Phase 3 Tubber Lane Adamstown
Stage 1 Road Safety Audit

Stage 1 Road Safety Audit

JOB NUMBER: 210095			DOCUMENT REF: 210095RPT001_RSA1_Rev_1			
Revision	Purpose Description	Originated	Checked	Reviewed	Authorised	Date
1	Final Issue	JW	MD	MD	MD	17 th Dec 2021
0	Draft Issue	JW	MD	MD	MD	16 th Dec 2021

Figure 2.1 – Examples Where Boundary Treatment Could Compromise Forward Visibility

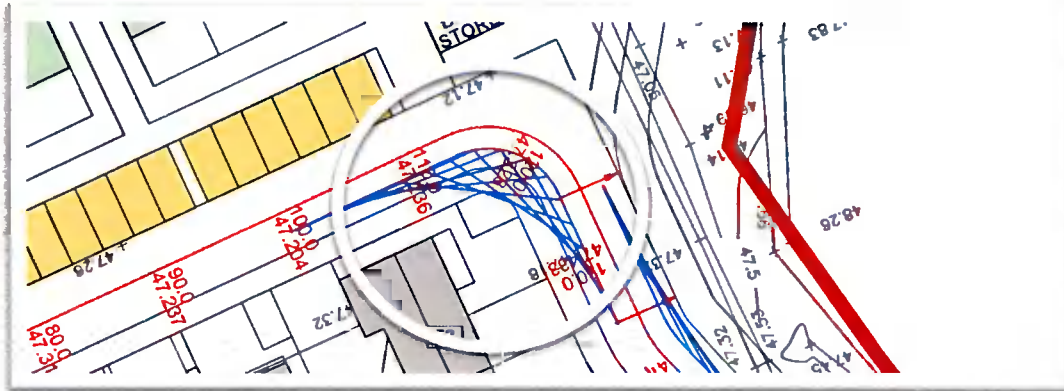
2.1 Problem: Forward Visibility Around Low Radius Corners

Location: Low Radius Horizontal Curves – Development Wide

Boundary treatments may block forward visibility around some low radius corners within the development roads. This could lead to rear end shunt type collisions.

Appropriate forward visibility should be provided around low radius corners within the development.

2.1	Yes	Yes	Wall/Garden railing will be adjusted inwards and footpath widened locally to allow for forward sight visibility around low radius corners.	<i>Noted with thanks.</i>

Figure 2.3 – Parking Obscuring the Presence of Pedestrian Waiting to Cross

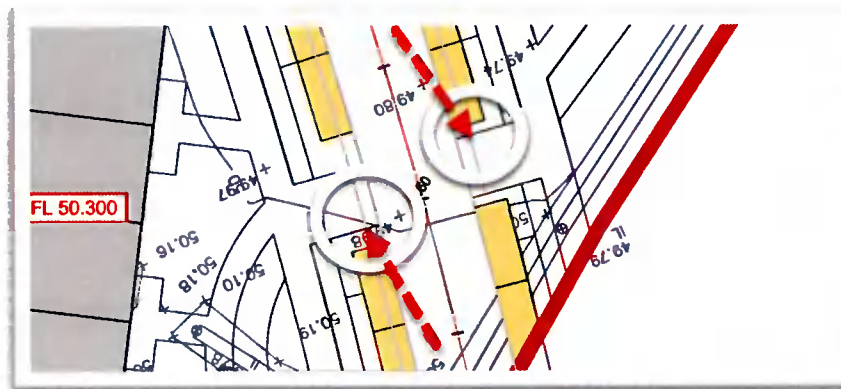
2.3 Problem: Parking Obscuring Visibility to Pedestrians

Location: Pedestrian Crossing on Drawing 20065 / 103

The close proximity of the parallel parking may obscure the presence of a pedestrian waiting to cross from an approaching driver's vision. This could lead to conflicts between vulnerable road users and vehicles.

The parking should be re-positioned to improve forward visibility to a pedestrian waiting to cross the road.

2.3	Yes	Yes	Car parking to be repositioned to improve forward visibility to the pedestrian crossing.	<i>Noted with thanks.</i>
